# Access Compliance Report

## Public Rights-of-Way

### (Curb Ramps)

Intersection ID: N/A	Main Street: OLD_WAYSIDE_RD	Cross Street: ARDREY_STEAD_CT	Location: SE
ADA ID: 4E9BC987669A	Ramp Type: Perp	Initial Pass/Fail: Fail	Overall Compliance: No
Severity Score: 37.5			
Codes/Mitigation Info/Possible Solution		Field Measurements/Component Compliance

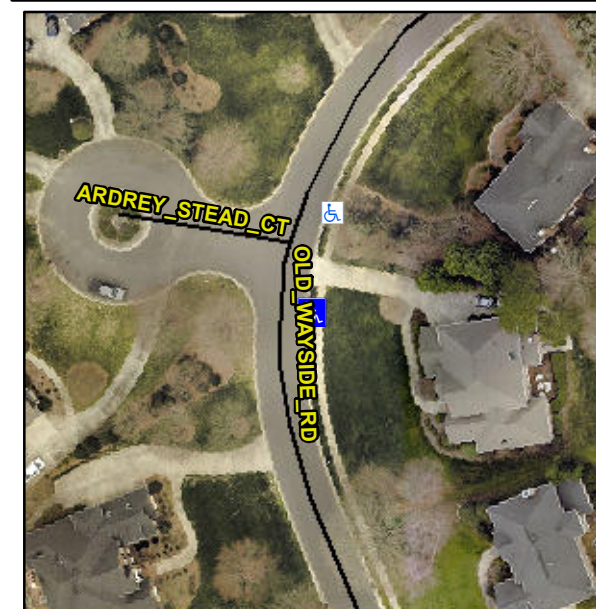
**Not Found, R304.2.2, R304.5.3**

Compliance	Description	Data	Compliance	Description	Data
N/A	Ramp Length (in)	48.0	No	Ramp Slope (%)	9.4
Yes	Ramp Width (in)	48.0	No	Ramp XSlope (%)	7.2
N/A	Flare Type LT	N/A	N/A	Flare Type RT	N/A
N/A	Flare Slope LT (%)	N/A	N/A	Flare Slope RT (%)	N/A
N/A	Flare Traversable LT?	N/A	N/A	Flare Traversable RT?	N/A
N/A	Landing Length (in)	N/A	N/A	DWS Provided?	N/A
N/A	Landing Width (in)	N/A	N/A	DWS Contrast?	N/A
N/A	Landing Slope (%)	N/A	N/A	DWS Length (in)	N/A
N/A	Landing X Slope (%)	N/A	N/A	DWS Full Width?	N/A
N/A	Landing Curb? (Y/N)	N/A	N/A	DWS Offset (in)	N/A
N/A	Shared Landing?	N/A			
N/A	Gutter Ponding?	N/A	N/A	Gutter Slope (%)	N/A
N/A	Gutter Lip Ht (in)	N/A	N/A	Gutter X Slope (%)	N/A
N/A	Painted X Walk1?	No	N/A	Painted X Walk2?	N/A
	X Walk 1 Direction	To NW		X Walk 2 Direction	N/A
N/A	X Walk 1 Width (in)	N/A	N/A	X Walk 2 Width (in)	N/A
	X Walk 1 Slope (%)	3.0		X Walk 2 Slope (%)	N/A
	X Walk 1 X Slope (%)	6.0		X Walk 2 X Slope (%)	N/A

**Remove & Replace Entire Ramp.**
